ATLASSIAN CENTRAL DEVELOPMENT

SSD-10405 RESPONSE TO SUBMISSIONS & SUPPLEMENTARY DESIGN REPORT

30/06/21

FIGURE 1 - CROWN AXONOMETRIC

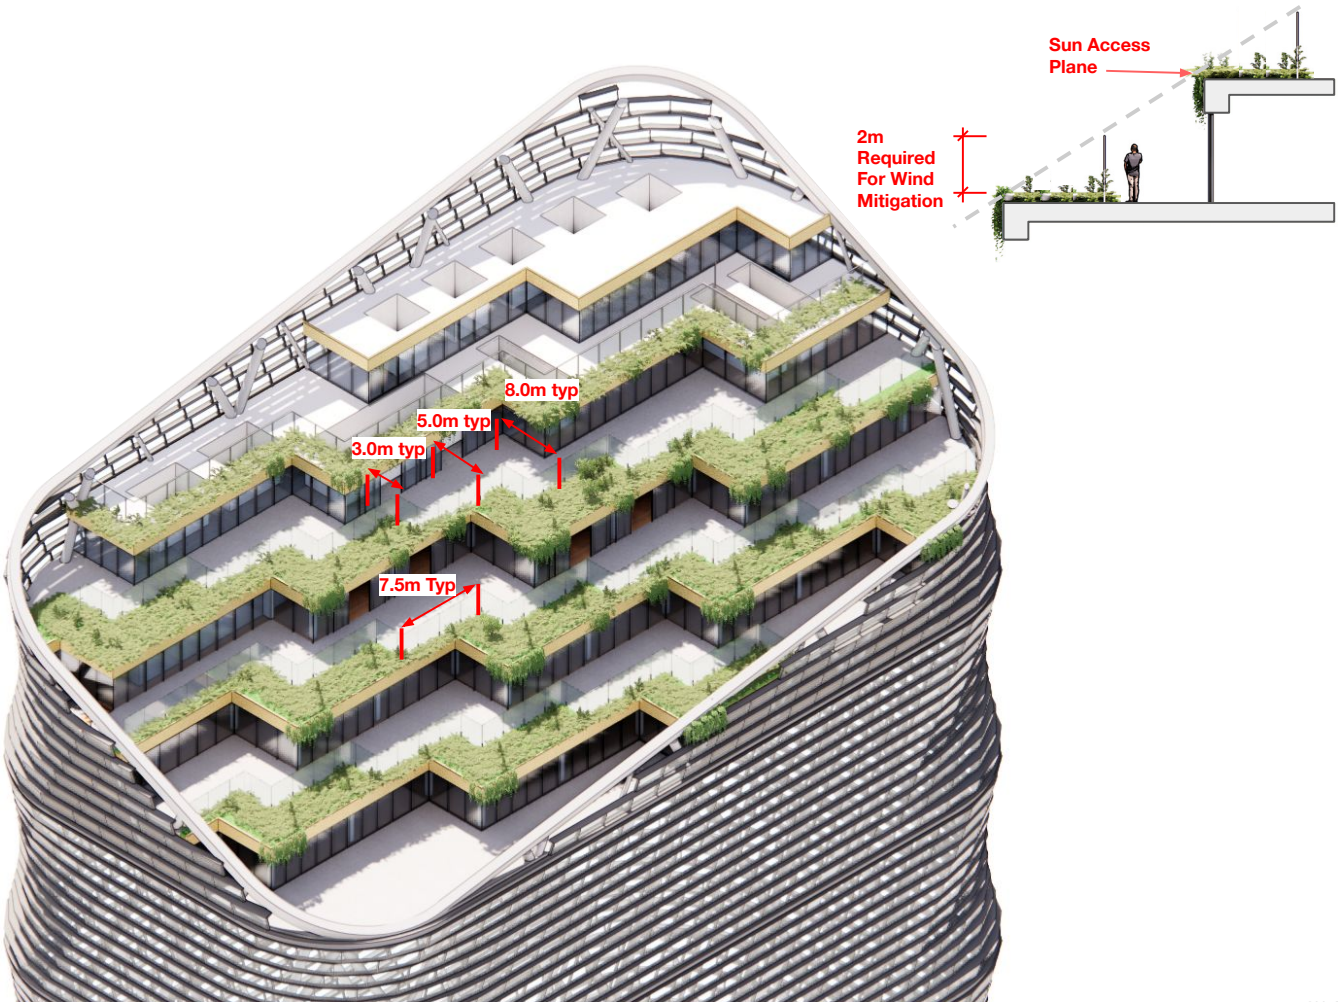
City of Sydney Comments	Response
General	
This is avoidable and can be fixed. The development overshadows Prince Alfred Park by way of high glass balustrading to the roof terraces. The sun access plane forms part of the Central Sydney Planning Strategy sets the limit for overshadowing over the park.	The roof top balustrades to terraces have been redesigned to be below the sun access plane. Refer 1.1.1.1 CoS Comment
The City strongly objects to this overshadowing beyond the limit - it breaches the sun access plane to the park. This has previously been brought to the applicant's attention and is easily remedied. The section below shows the extent of balustrade which causes the impact. Reducing the extent of private terrace footprint and height of glazing (and its structural support) will remove the impact completely and comply with the limit of allowable shadow. The Department should avoid a precedent for future development at Central Station and enforce compliance with the sun access plane. 	The roof top balustrades to terraces have been redesigned to be below the sun access plane. Refer 1.1.1.2 CoS Comment

Balustrades and landscape design and details will be further developed in later stages of design.

FIGURE 1 - SECTION THROUGH EAVES

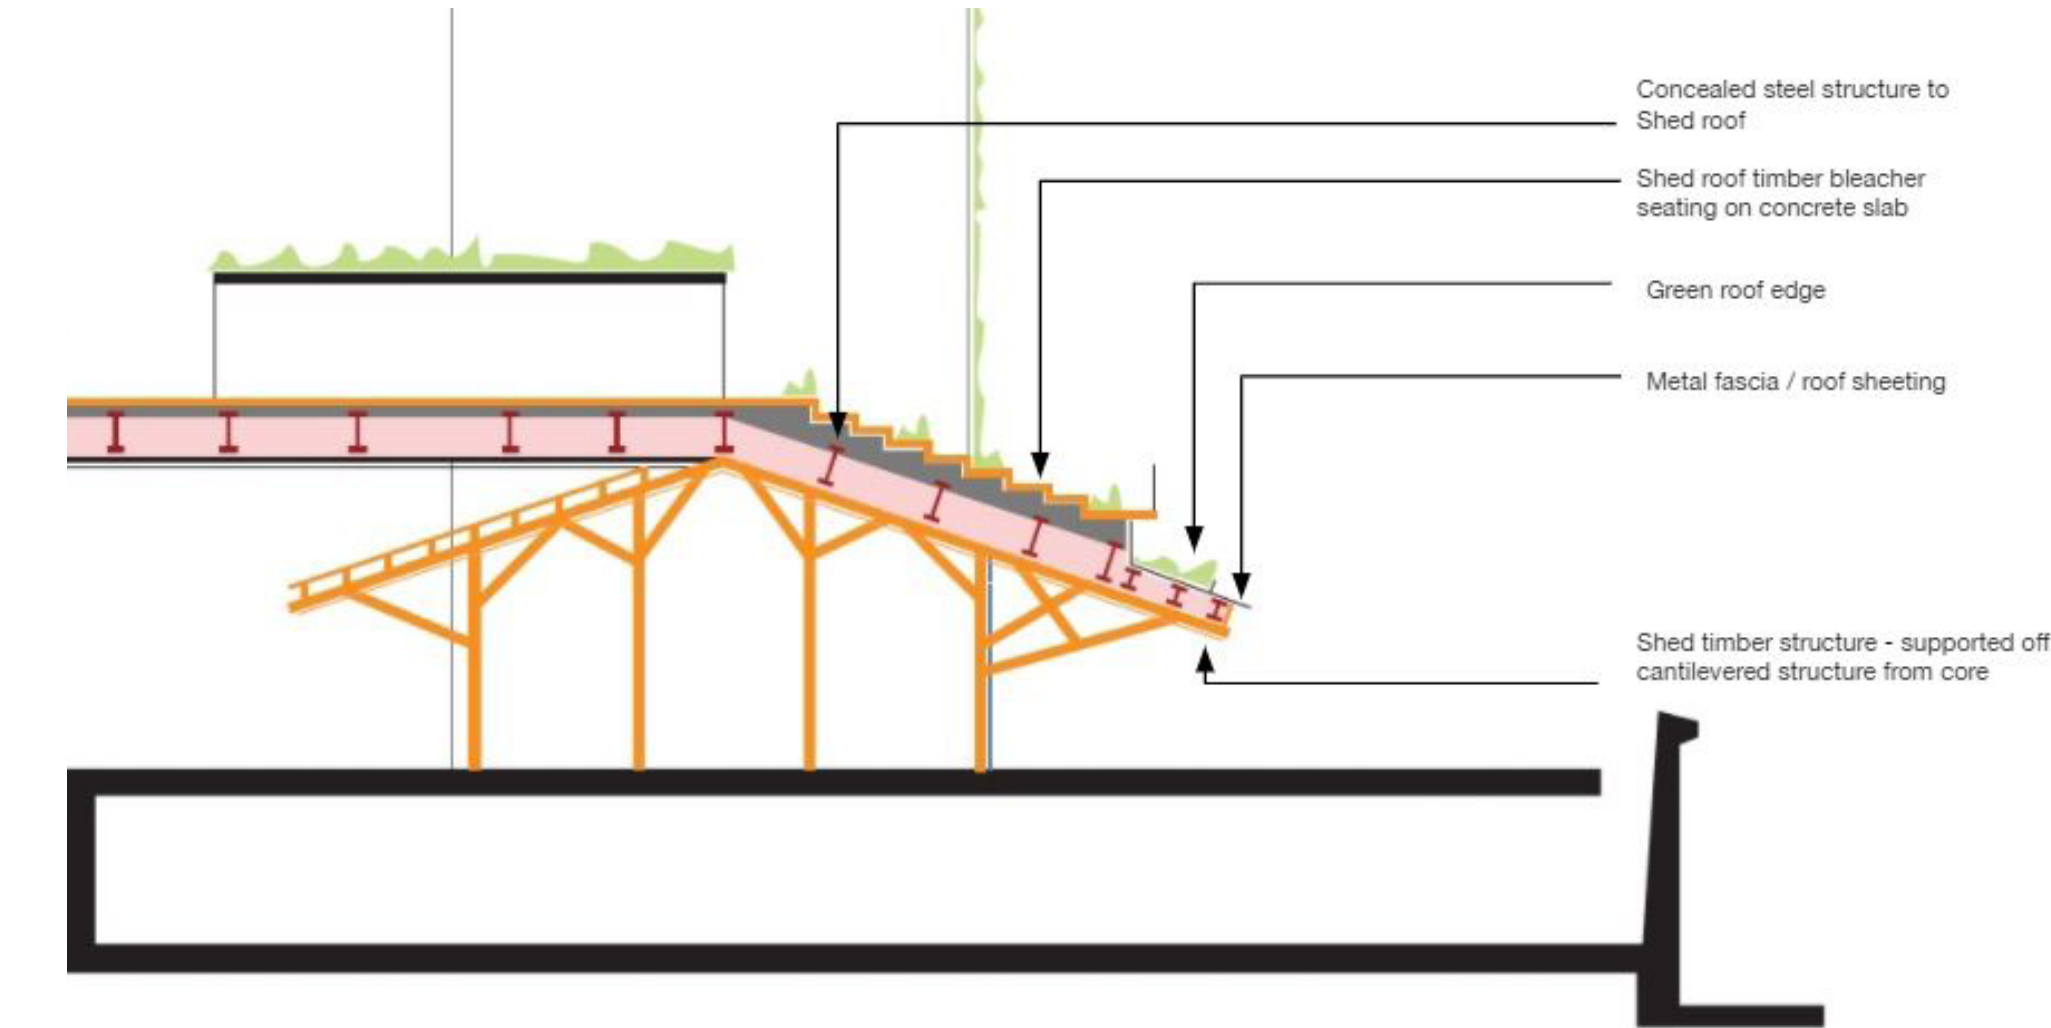
The addition on top of the existing parcel shed roof to the south-eastern side (clouded in red on the image below) interfere with the visual and physical separation required between the existing and the tower addition. As well, the former roof form and materiality is hidden by the top addition. Consideration should be given to reducing the overall impact of this element. 	Refer 1.1.4 CoS Comment

1.1.4 COS COMMENT:
OSD & SHED ROOF

The existing structure for the Inwards Parcel Shed will be separate, and will not carry the new structure to the OSD level. See figure 1.

The OSD structure will not be visible from the public domain by virtue of a new timber soffit which will infill between the existing timber structure below. See figure 2.

FIGURE 1 - PLATFORM 1 ELEVATION - PREVIOUS PROPOSAL

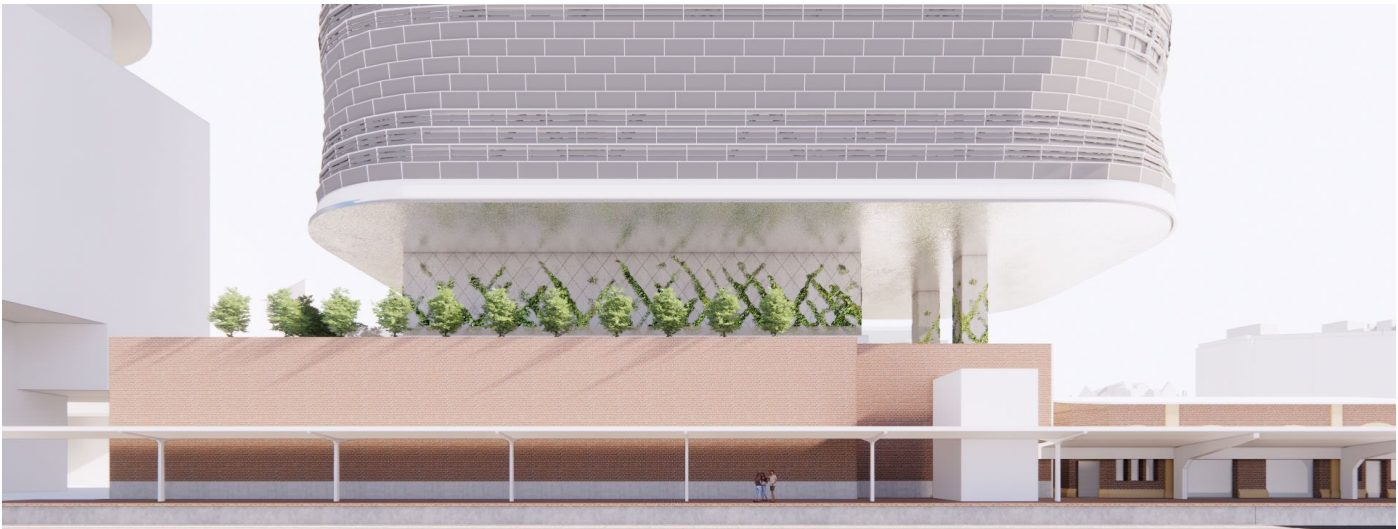
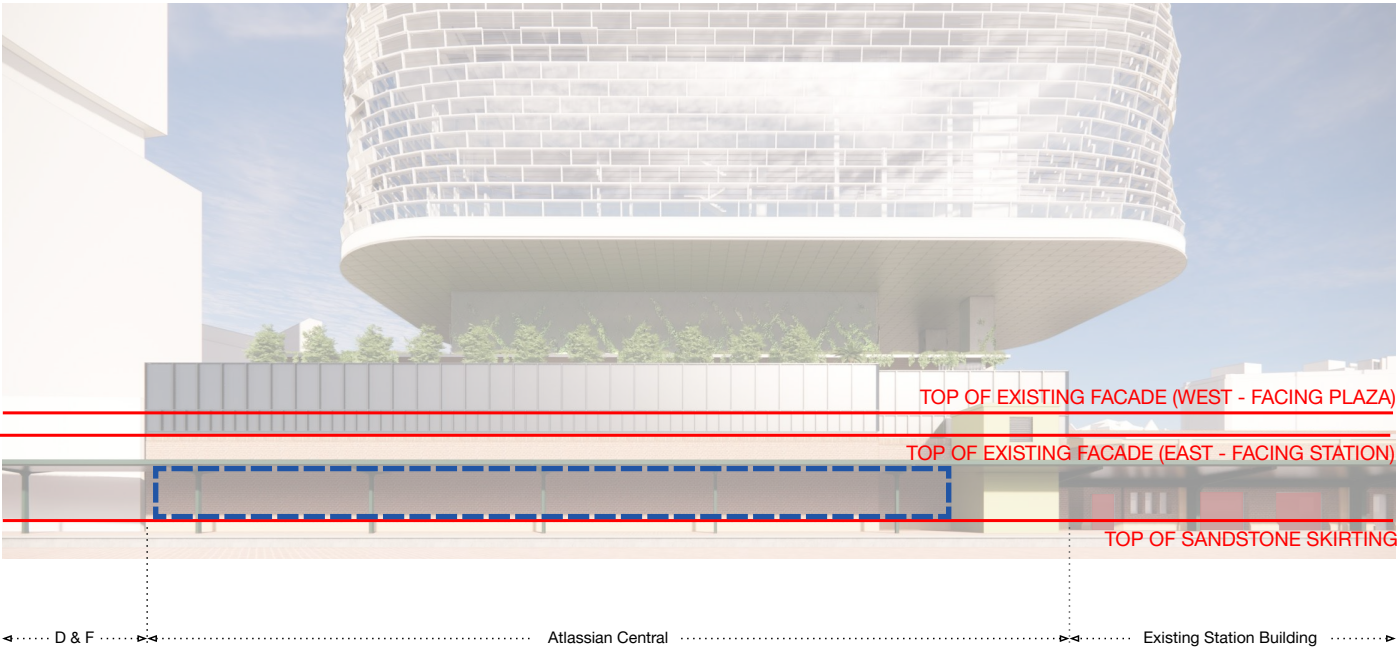
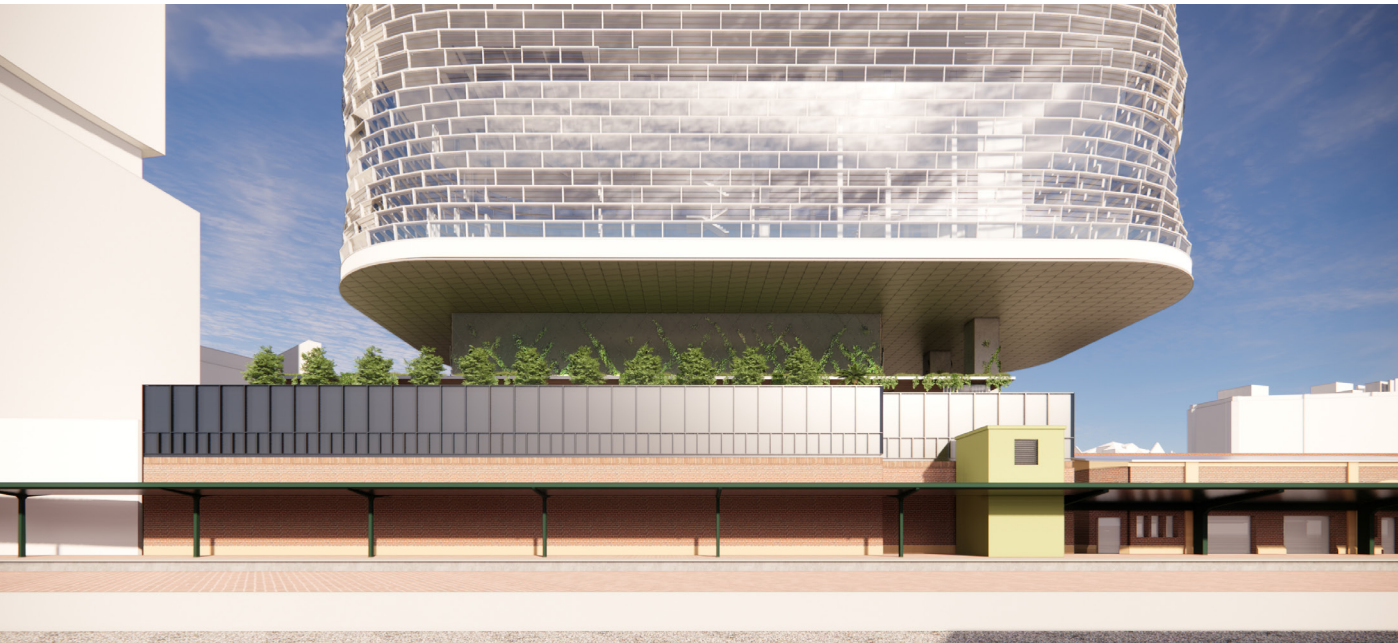
City of Sydney Comments	Response
The blank wall on the ground floor on the eastern elevation separating the train station does not deliver any connectivity or engagement between the new development and the station. The City understands this wall is essential for fire and blast separation between the rail line and the new building (e.g. if a diesel train derails at platform 1 or 2). Its scale and impact need to be ameliorated by modelling or sculpting the wall in three dimensions with piers or other architectural features and must have a design quality and materiality commensurate with the existing quality of Central Station. The wall could also be an opportunity for a public artwork. The importance of this wall appearance is high if these platforms are to be built over in future.	Refer 1.1.5 CoS Comment
The large amalgamated arch facing Ambulance Avenue needs more work and is considered to be out of scale and unsympathetic in the context. In its current form, it would result in a substantial loss of the fine and significant original brick masonry. This new access to the shopping concourse to the south should be delivered as three new arches within the existing brick pier set out. These need to be consistent with the scale, classical proportions, geometry, wall thickness and construction detailing of the existing brick arches in the wall. The proposed demolition of the existing brick wall must be preceded by accurate survey of the existing fabric including a point-cloud laser scan of the entire wall and an inventory of all elements to be salvaged including sandstone elements and metal work. The brick wall must be reconstructed to the same brick rod (i.e. mortar joint) set out of the retained east end of the wall (note that the beds and perpends in the existing brick wall are less than the modern standard of 10mm). All existing brick piers should be reconstructed to full height to match their original size, design and position. Please note that this was relayed to the applicant in preliminary discussions and was agreed in principle at the time.	Refer 1.1.6 CoS Comment

1.1.5 COS COMMENT:
EASTERN ELEVATION

FIGURE 2 - AMBULANCE AVENUE OPENING - SSDA SUBMITTED PROPOSAL

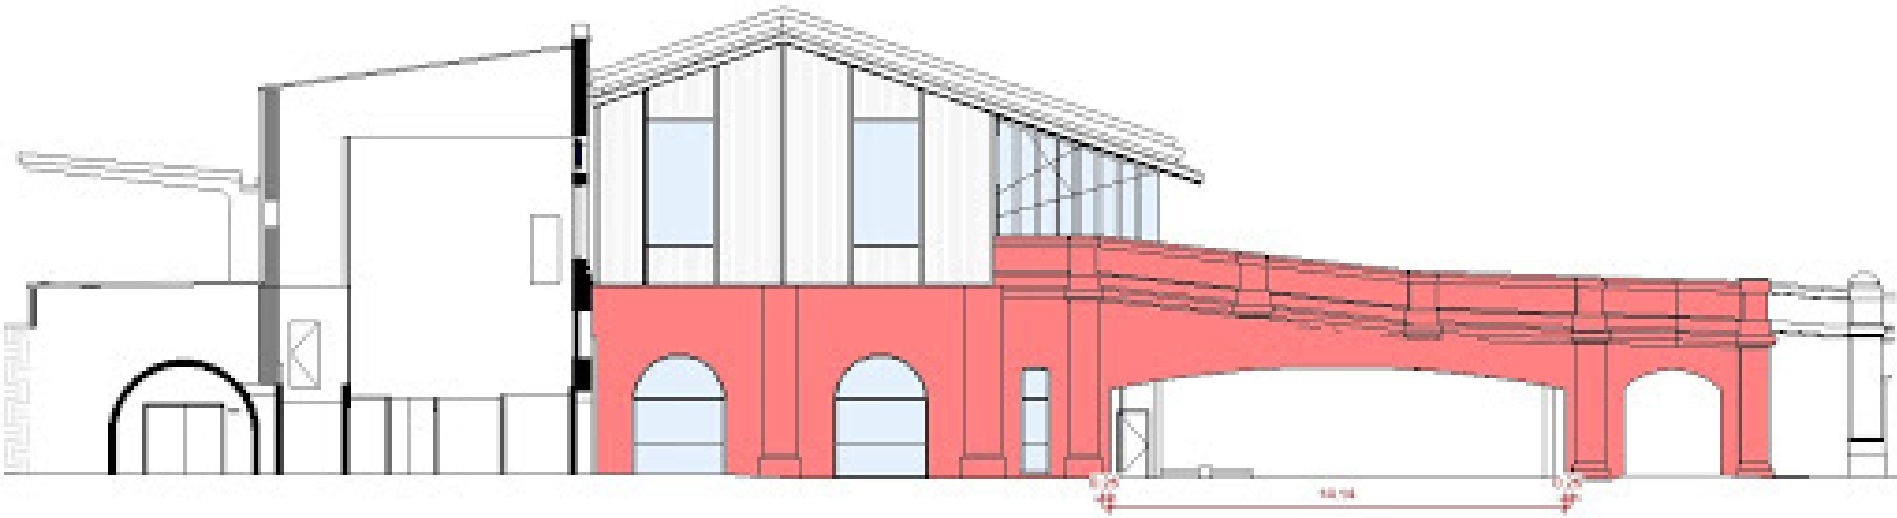
1.1.6 COS COMMENT: ARCH FACING AMBULANCE AVENUE

- 1. 3 equal arches as recommended in comment. (See Figure 1)
- 2. 1 large and 1 small arch. (See Figure 2)
- 3. 1 large arch with the sides reduced compared to the current large arch 11 metres wide. (See Figure 3)

The results showed that Figure 1 with 3 equal arches as suggested in the comment does not meet TfNSW requirements and does not accommodate for future pedestrian volumes through the Link Zone. See figure 2)

FIGURE 1 - NATURALLY VENTILATED LOBBIES - UPPER GROUND

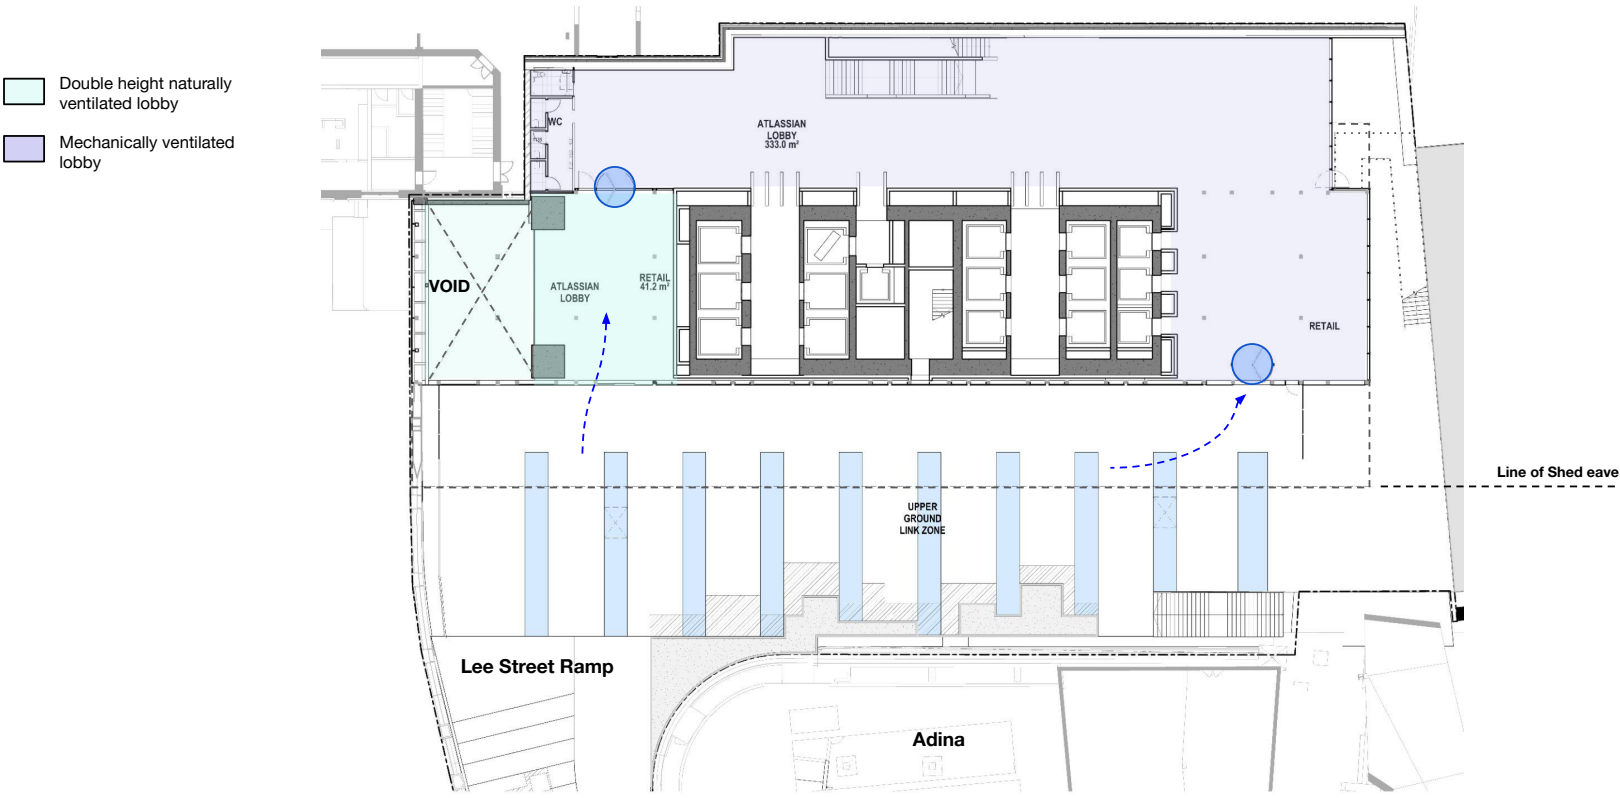
City of Sydney Comments	Response
The visual impact of the large glass cladding of the shed on northern elevation is uncharacteristic, somewhat bland and looks unfinished. In addition, considering the north orientation, it will negatively impact on energy performance. A preferable solution may be to undertake an interpretative re-construction. The original windows could be refurbished and returned to their original locations in the elevations. The areas of (formerly solid weatherboard) walls surrounding them may be glazed but clad with build external timber horizontal louvres based on the proportions and materiality of the original weatherboard cladding. This can deliver an appropriate level of passive sun control and present a more solid appearance more consistent with the original building. This would allow clear glazing and so would allow very good visual connection between the interior and exterior in all lighting conditions.	Refer 1.1.7 CoS Comment

1.1.7 COS COMMENT:
VISUAL IMPACT OF GLASS
TO NORTH ELEVATION

Figures 1 & 2 show the extent of the naturally ventilated lobbies which is bound by opeable facades to the north and west at both lower ground and upper ground.
